Accessibility Assessment Report

Project Address: 23 The Corso, Manly NSW 2095

Report Number: 183801

Revision: 05

1428.1 Clause	Title	Assessment and Comment	Status
		 <p style="text-align: center;">Figure 6.5</p> <p>Construction documentation should demonstrate compliance.</p>

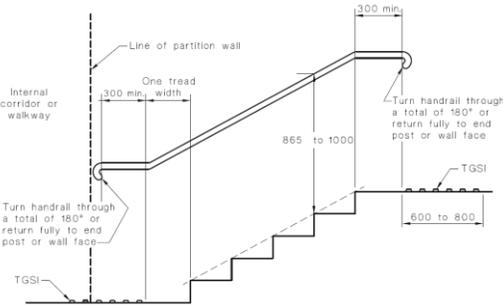
6.5	Circulation space for wheelchair turn	Accessways require turning spaces in accordance with AS1428.1-2009. 60°-90° turns require a minimum circulation space of 1500 x 1500mm with a gradient of not more than 1:40. 30°-60° turns where the width of path of travel is less than 1200mm, require a splay of 500 x 500mm at the internal corner. 90°-180° turns require a minimum circulation space of 1540 x 2070mm as per Figure 6.5 below.	Capable of Complying
